**From:** Saliaries, Gwen N - DNR  
**Sent:** Monday, September 19, 2022 10:25 AM  
**To:** Brian Wayner  
**Subject:** RE: Miller Electric Melvin Street Substation

**MILLER ELECTRIC MANUFACTURING COMPANY**  
**PROPOSED MILLER ELECTRIC**  
**SUBSTATION EXPANSION**  
 1515 W MELVIN STREET  
 CITY OF APPLETON, OUTAGAMIE COUNTY, WISCONSIN

SCALE:  
 1" = 20'  
 PROJECT NO.  
**R3001507.00**  
 FIGURE NO.  
**A-1**

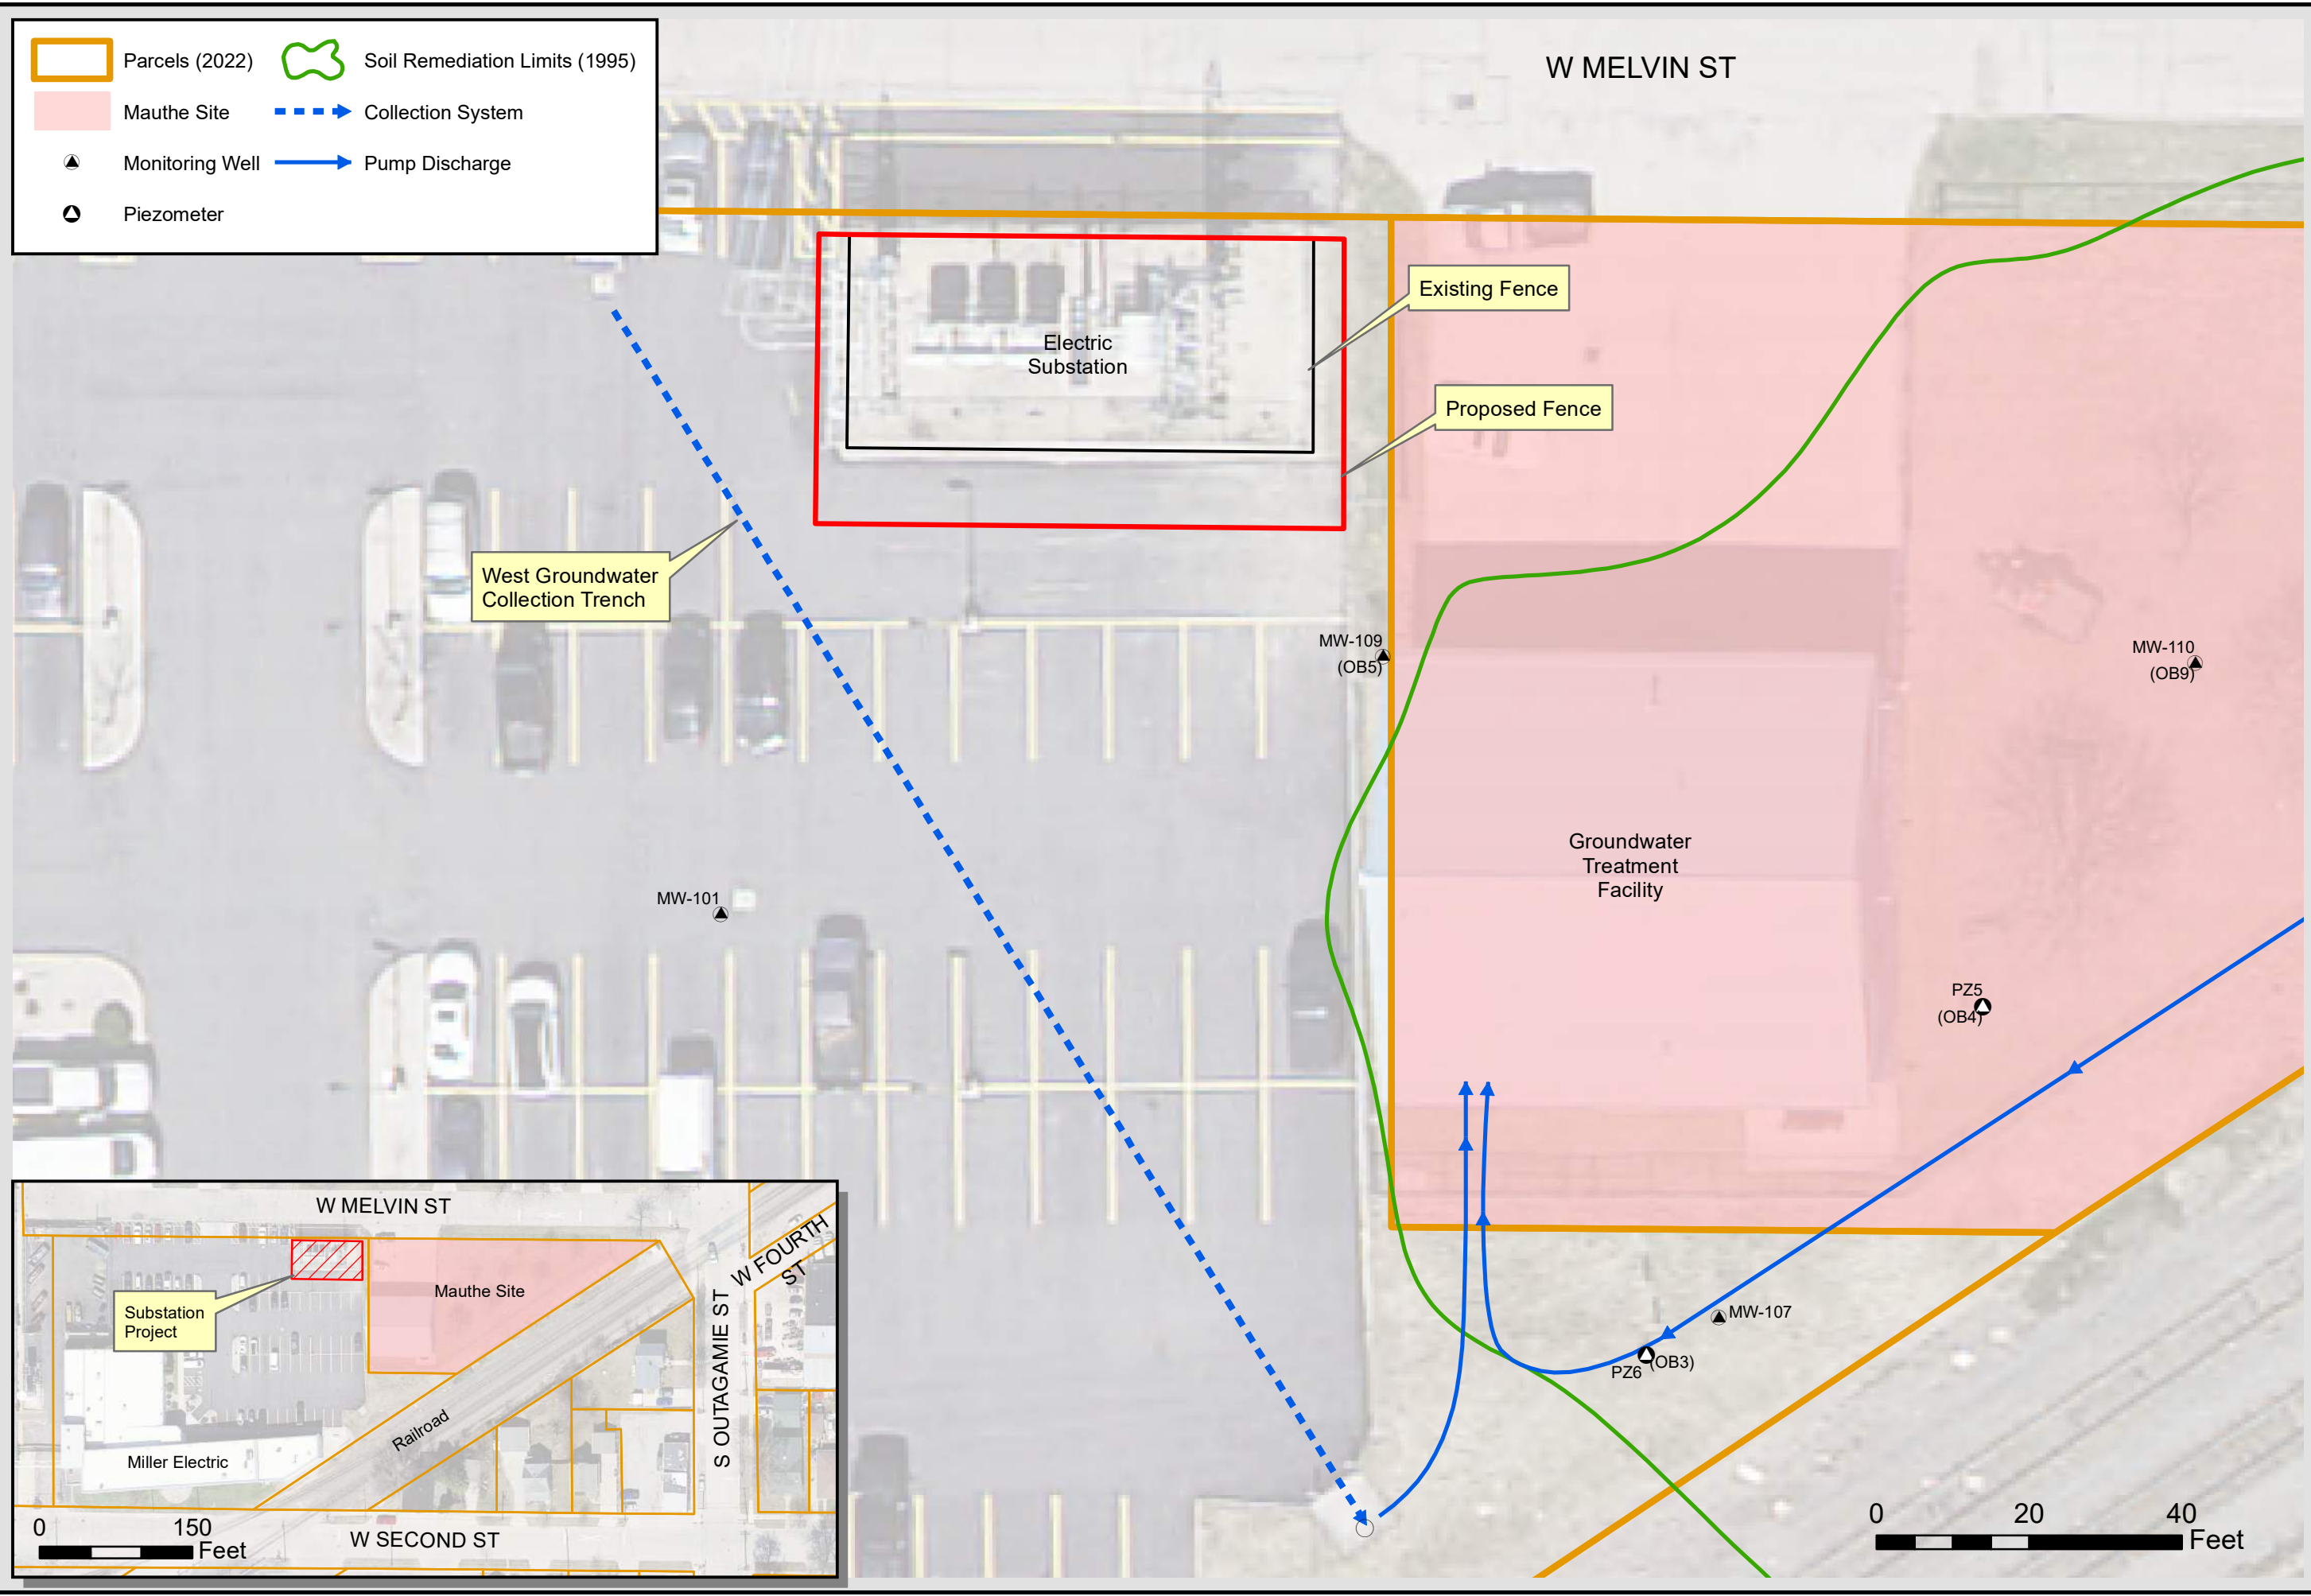
Since the proposed expansion won't impact any monitoring wells or the groundwater trench I don't have any concerns or need any additional information. I'd be interested to see the soil results from your characterization if you are able to share those with me. Thank you for checking this with me,
